**Approved AsNoted**  
 BY: Ken Upmal  
 DATE: 11/29/2017  
 RESUBMIT: NO  
 RECEIVED: November 13, 2017  
 CKD BY: DV/BK (Green Intl.)  
 STATE OF VERMONT  
 AGENCY OF TRANSPORTATION

<b>72 X 72 WATERMAN MODEL          QS-5000-F-Y          SLUICE GATE</b>	FOR:RENAUD BROS.,INC 283 FORT BRIDGMAN RD#2 VERNON,VT 05354 Po:SIGNED QUOTE 8/9/17 REF:AGENCY OF TRANSPORTATION	REV.NO. [4] DATE NOV. 07, '17 AMW BY FS JOB NO. M028960C PROJECT MANAGER FRANK SOTO
		REF:AGENCY OF TRANSPORTATION	REV.NO. [3] DATE SEPT. 05, '17 AMW BY FS JOB NO. WQ17-H-28960C DRAWN BY AMW CHECK'D BY REM ENGINEER AMW SHEET 1 OF 1
			REV.NO. [2] DATE AUG. 31, '17 AMW BY FS SCALE NTS DATE AUG. 18, '17
			REV.NO. [1] DATE AUG. 29, '17 AMW BY FS DRAWING NO. RB-17-0487

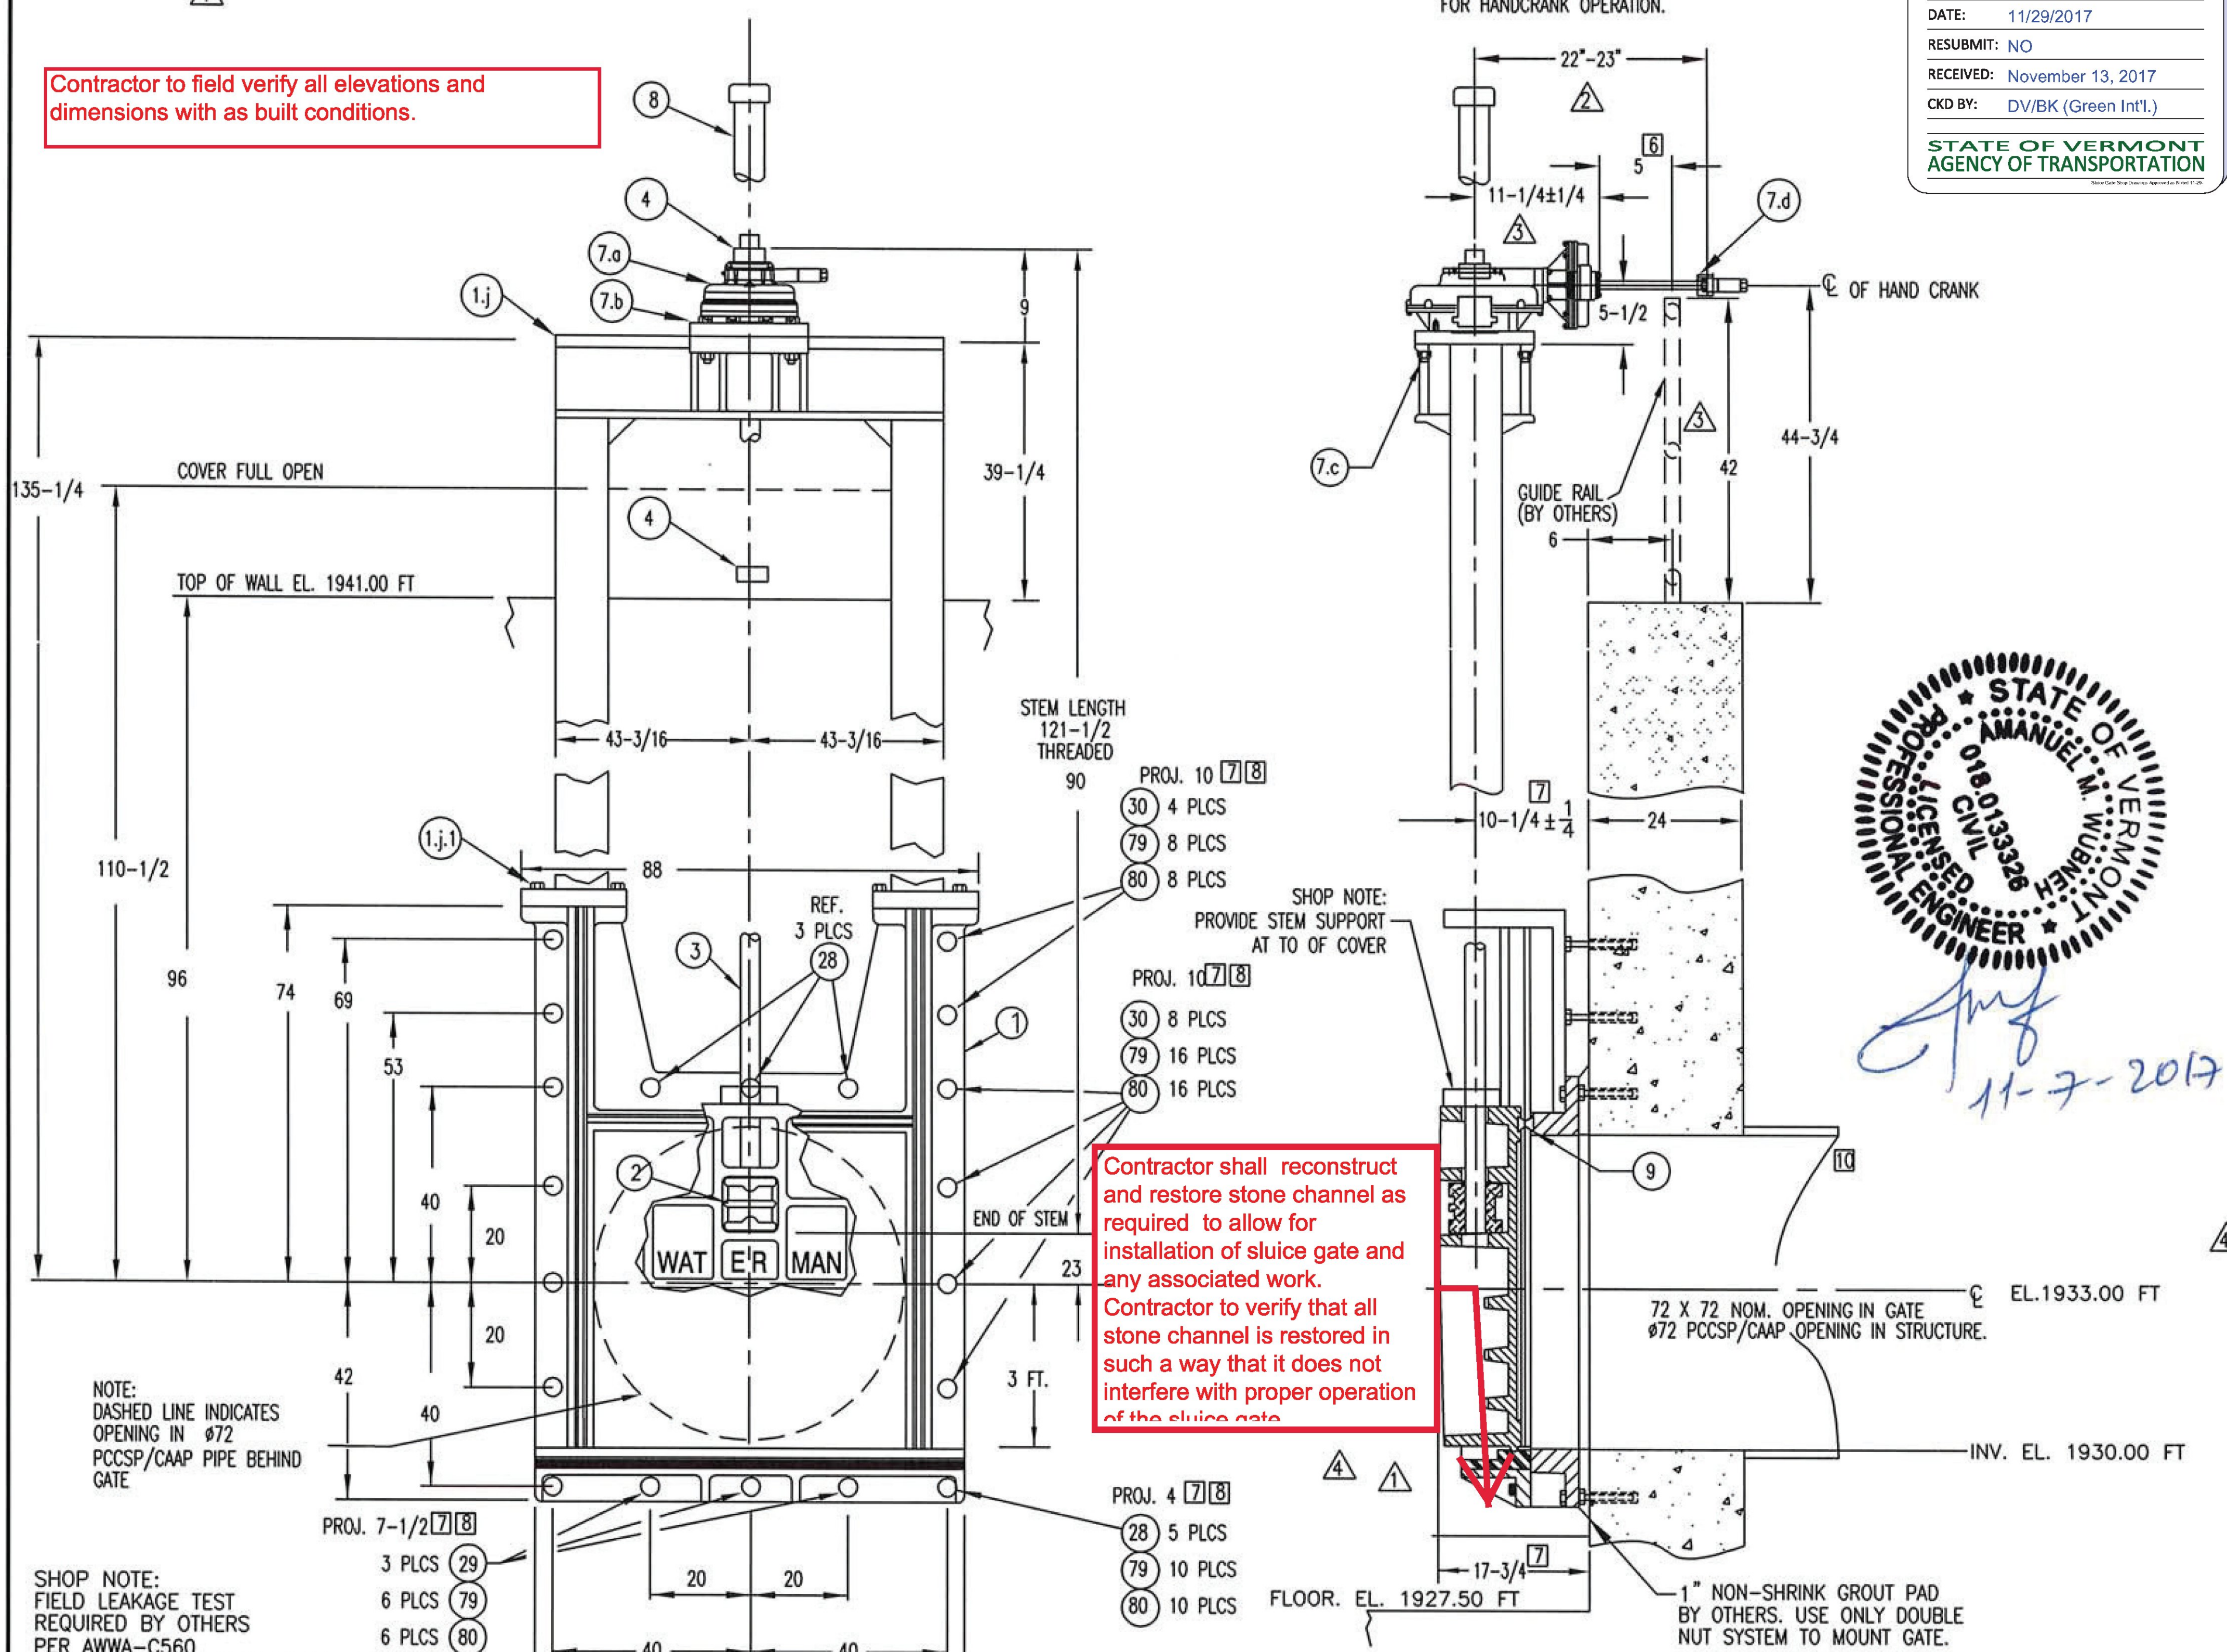
Contractor to confirm in the field that adequate clearance will be provided.

Contractor to field verify all elevations and dimensions with as built conditions.

Contractor shall reconstruct and restore stone channel as required to allow for installation of sluice gate and any associated work. Contractor to verify that all stone channel is restored in such a way that it does not interfere with proper operation of the sluice gate.

CONTRACTOR TO INSURE THERE  
 WILL NOT BE ANY DEBRIS/ SILT DEPOSIT ON THE SEATING SIDE OF THE GATE
